**FINAL DRAINAGE REPORT
FOR
STERLING RANCH FILING NO. 5**

March 2024

**Project No. 25188.16
PCD Filing No: SF-241**

STERLING RANCH FILING 5
EXISTING DRAINAGE MAP
JOB NO. 25188.16
03/12/2024
SHEET 1 OF 1

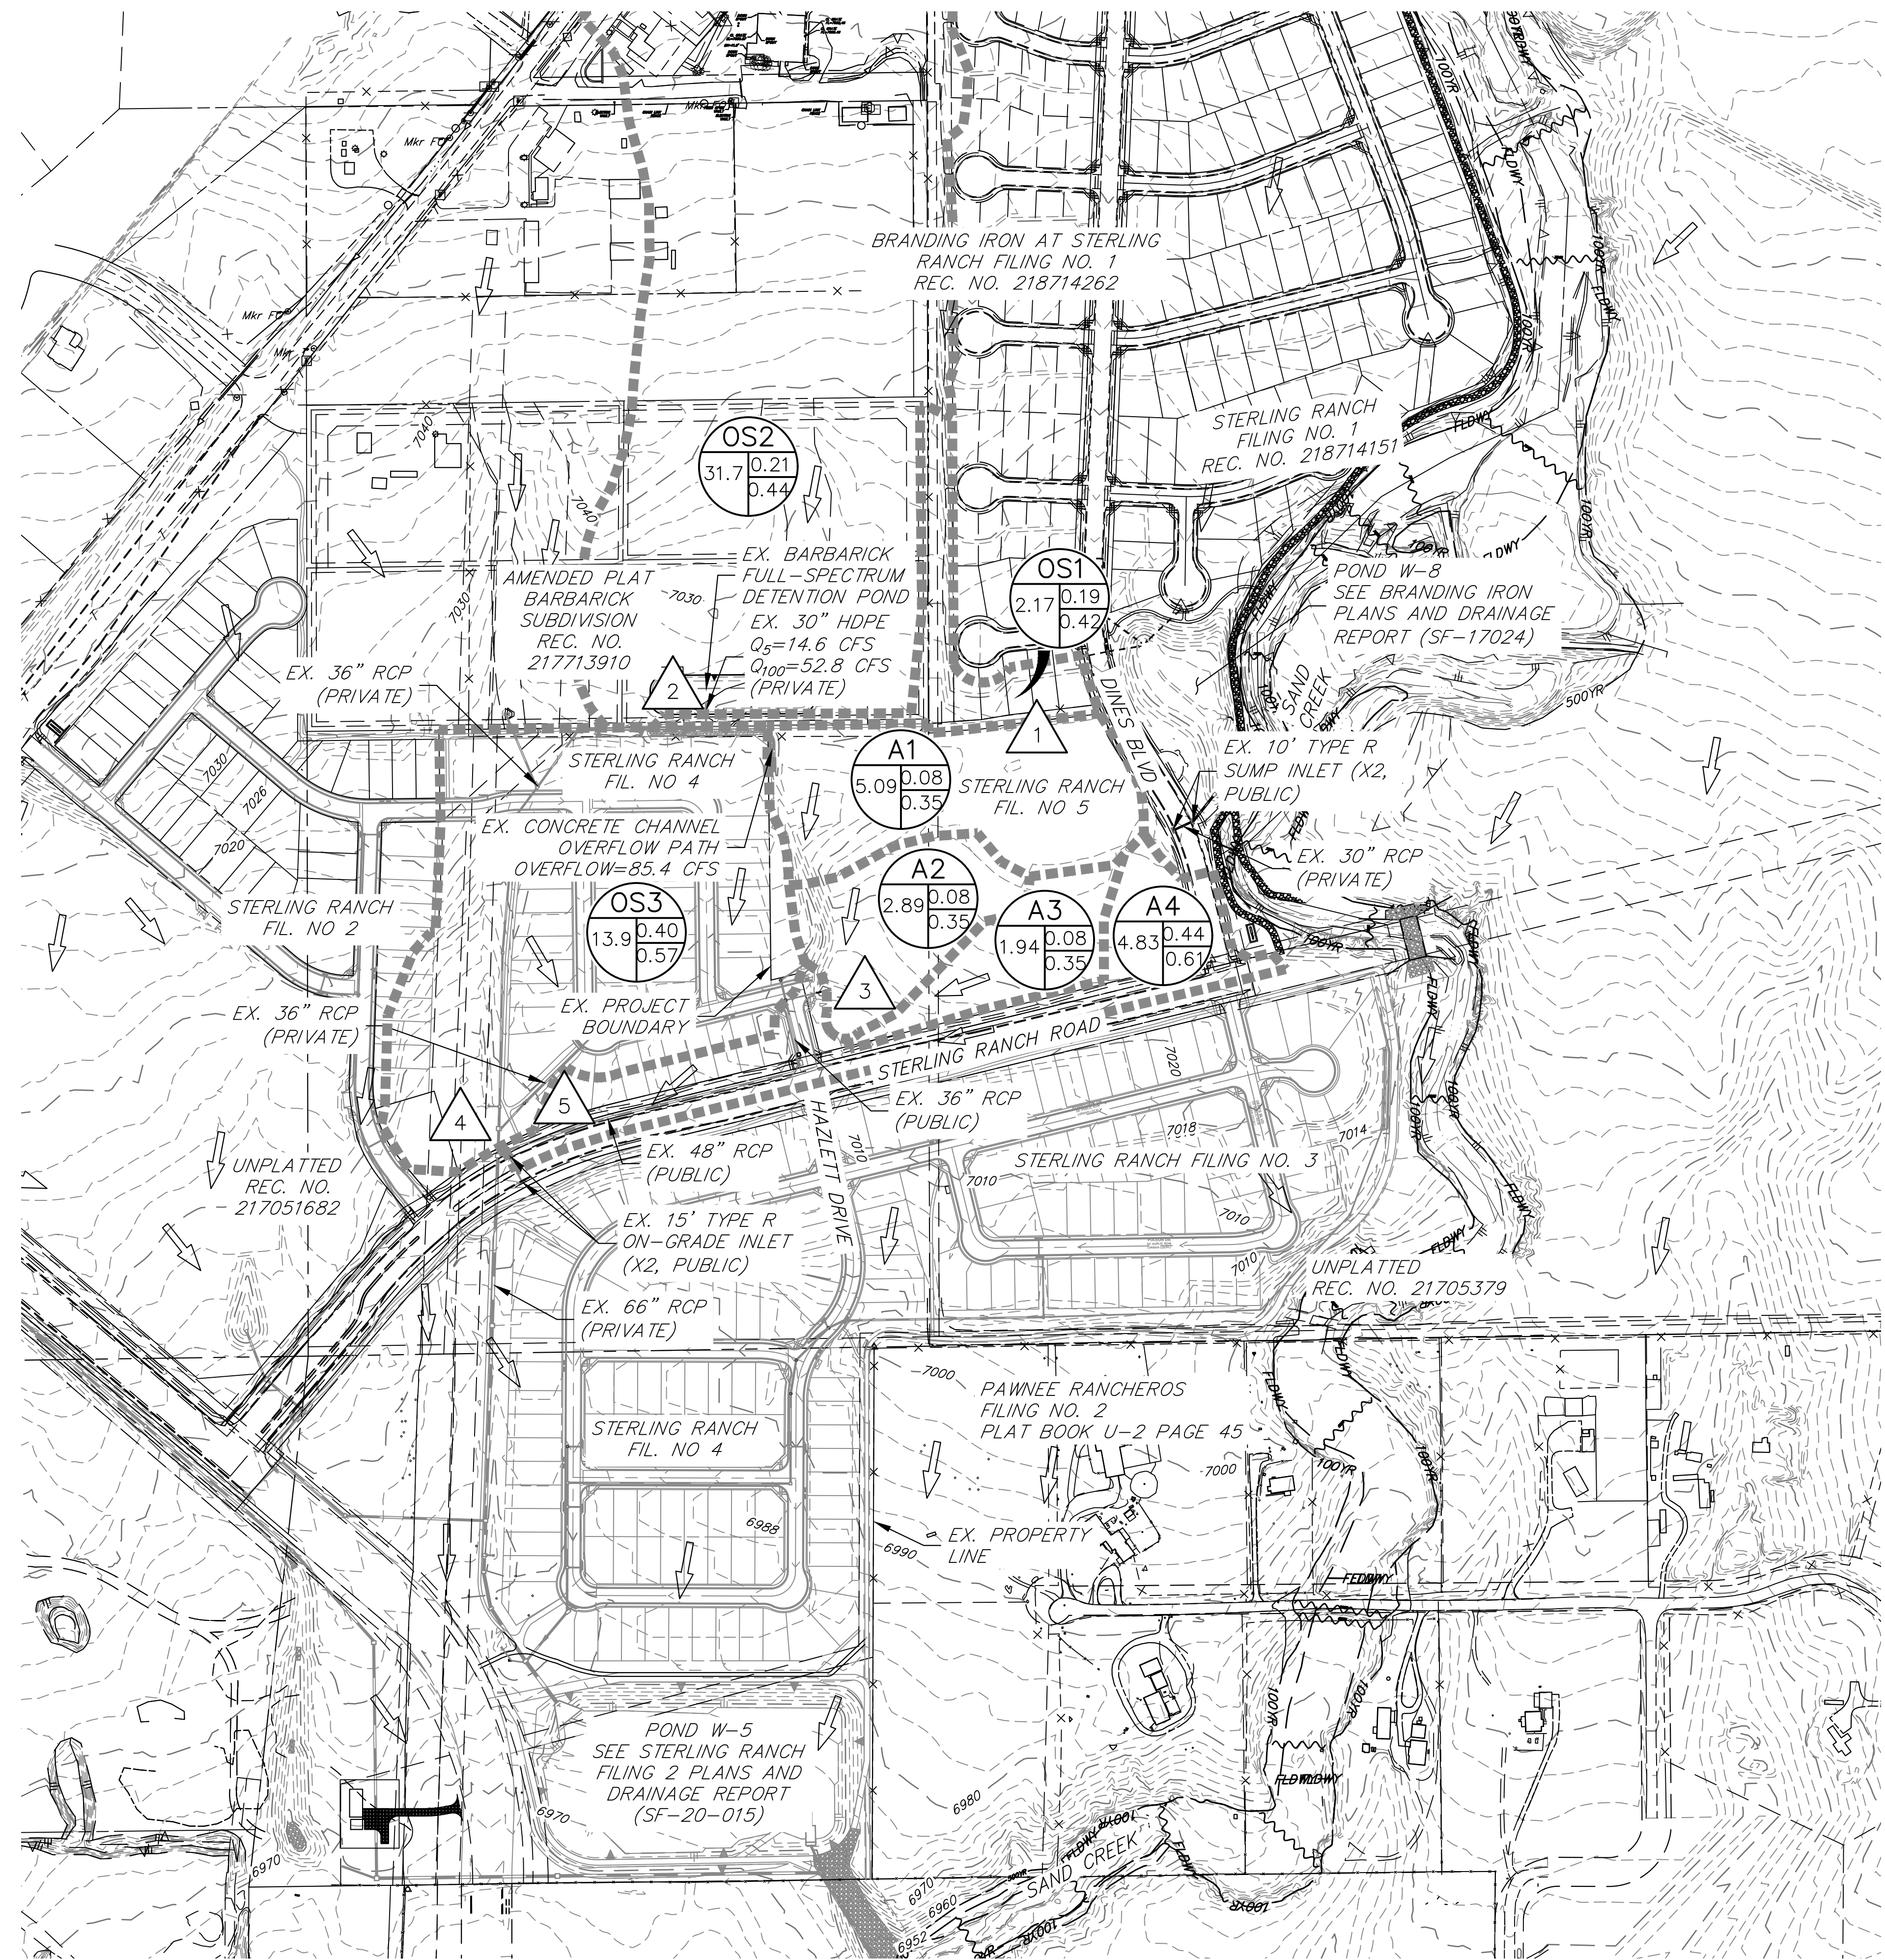
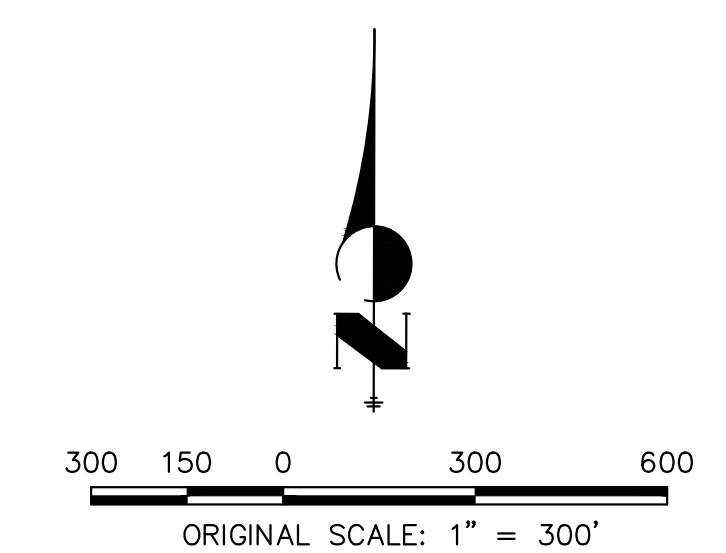
Unresolved - dotdits
04/17/2024 12:50:35 PM
Add note to see existing drainage map for extents of offsite basins
